Re: Variance Petition
Oak-Land Middle School Additions Project
Lake Elmo, MN

MEMORANDUM

To: Minnesota State Plumbing Board Date: December 10, 2024
From: Larson Engineering, Inc. Project No: 12246044
Project: Oak-Land Middle School Additions & Renovations
Re: Variance Regarding 2020 Minnesota Plumbing Code Section 310.5

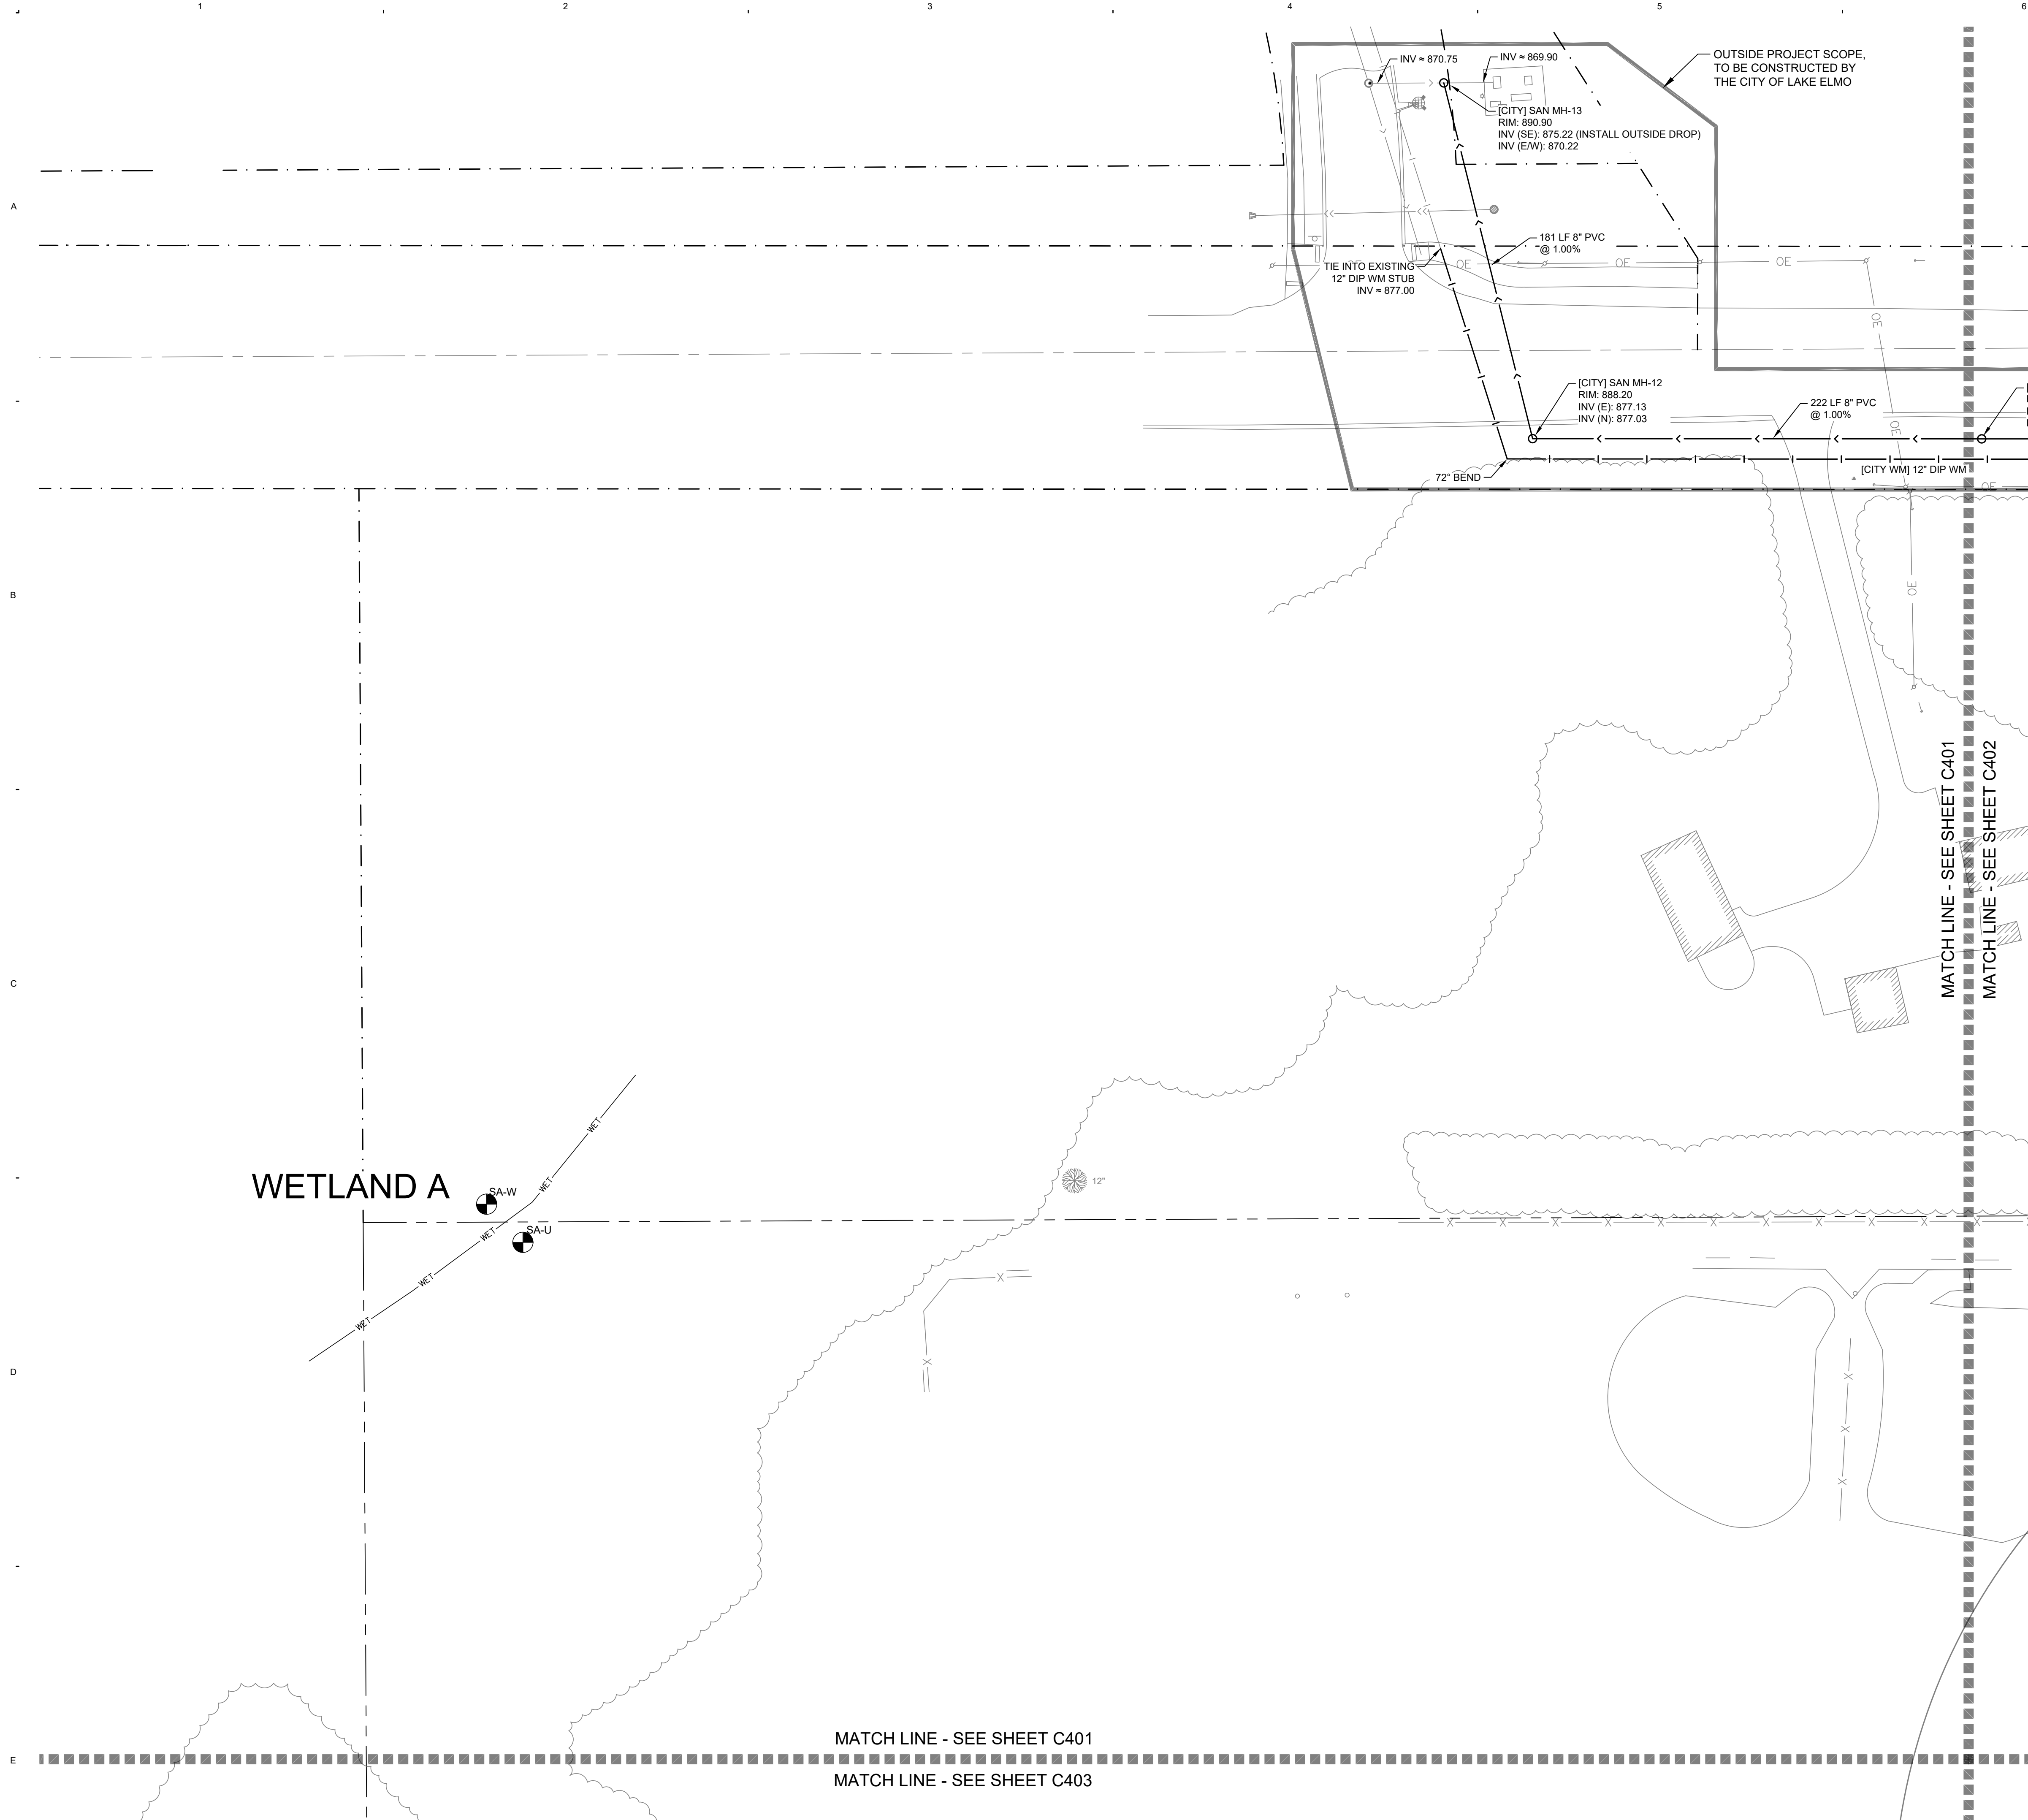
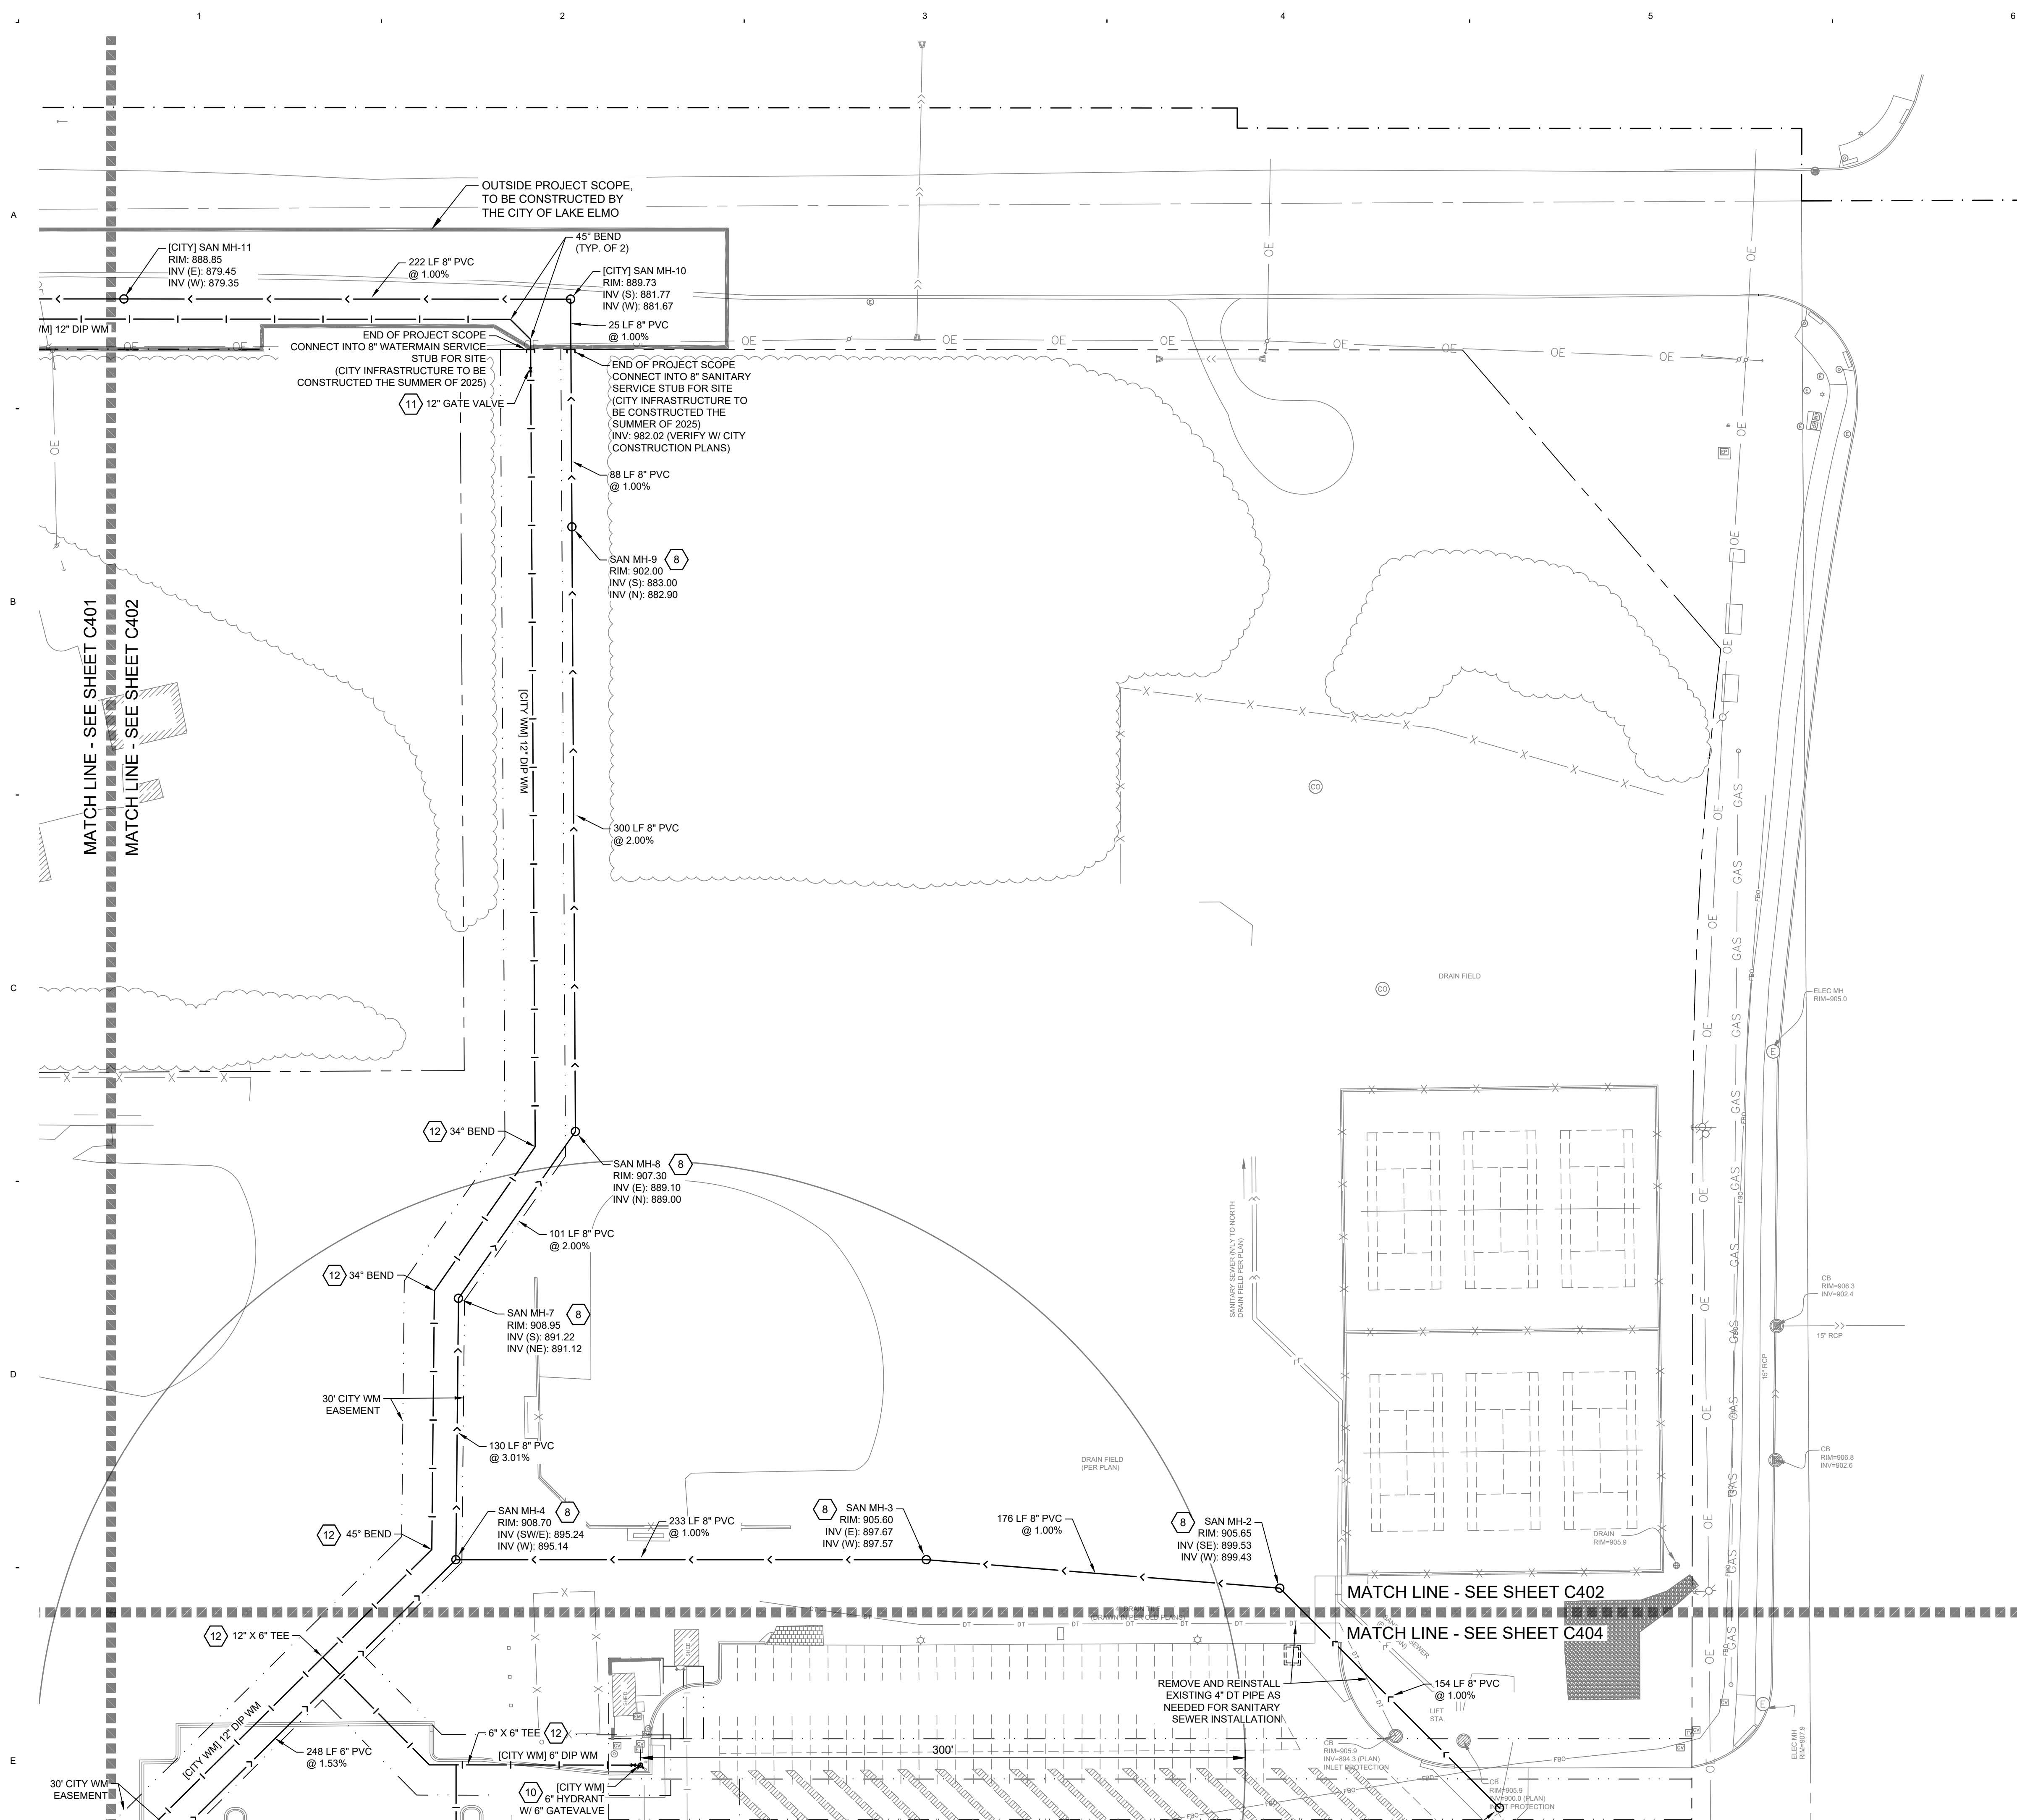
2. Provide a larger site plan showing elevations of the storm system, helps explain why you cannot connect to existing. Show other work that will be completed on the site. **I have attached utility drawings to this email that depict the design if the drywells are maintained, but please note that the stormwater system for the site are rather complex and cluttered. This was initially withheld from the submittal to prevent confusion. The attached plan sheets are not the most recent utility plans for the project as the project is set to start construction this spring and we needed to proceed forward with an alternate design that included a lift station to service the existing roof leader which greatly increased the cost of the civil related work.**
